LaSalle County Station Initial License Examination

Post Examination Comments and Documentation

Subject: Comments on NRC Initial License Examination administered the weeks of October 22 and October 29, 2012

LaSalle County Station NRC Initial License Examination Comments

35

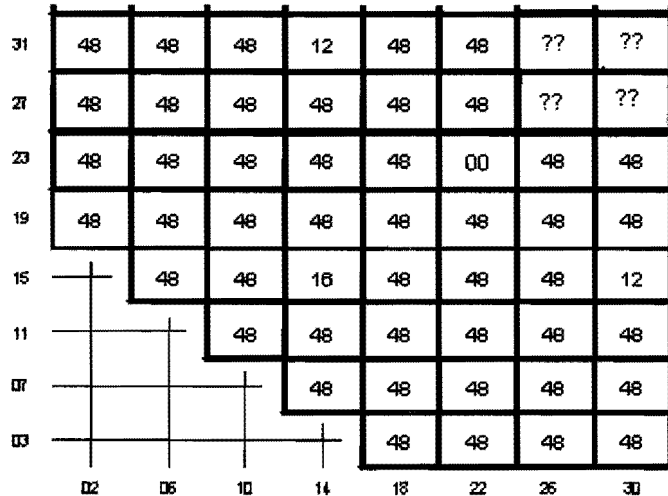
Candidate Comment: The comment made was when “??” is displayed it represents 4 rods that have Data Faults, which is answer (A) and is also correct based on new technical information.

Station's Response: The rod position text that is displayed by RCMS is based on the output value from the rod position indication system (RPIS) portion of the system. Per system description 047, a Probe Multiplexer (MUX) card not responding will cause an RPIS '255' signal to be generated which will then display “??” for the 4 rods controlled by that Probe MUX card.

This new technical information (**GE Propriety Class III Information data sheet DO NOT RELEASE**), shows that when a code 255 is present, a data fault bit is present (DF) and thus a data fault would be displayed on RCMS screens. This would make (A) a correct answer as well due to the limited information in the stem.

STATION RECOMMENDATION: ACCEPT BOTH (A and C) as correct answers.

60

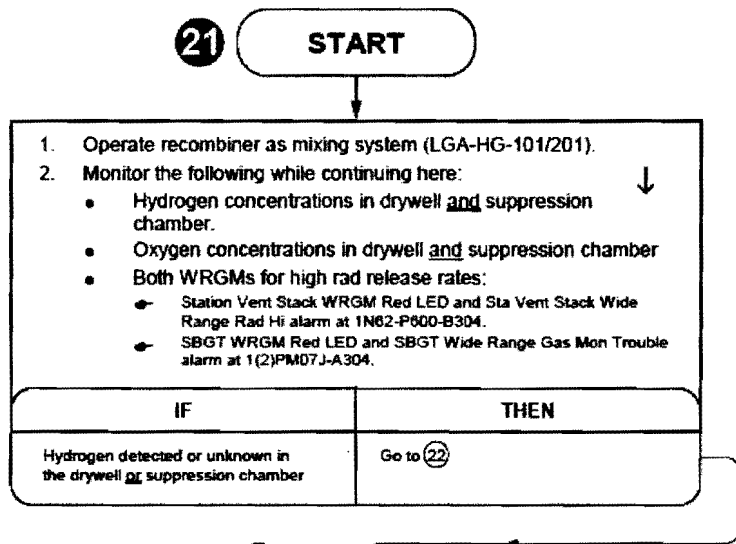
Candidate Comment: The comment made was that the plant is below 2% Hydrogen indication, therefore the Hydrogen leg of LGA-003 would not be entered making answer (A) correct as well.

Station's Response: LGA-003 lesson plan states if LGA-003 is entered than parallel execution is also required because of the symptomatic approach to emergency response precludes the prioritization of any one action path since independence for initiating events and transients must be maintained. Therefore the Hydrogen leg of LGA-003 is entered because the stem of the question states Hydrogen is 1% and rising slowly, which leads to entering LGA-011 and starting the Hydrogen Recombiner.

STATION RECOMMENDATION: ACCEPT ONLY (B) as the correct answer.
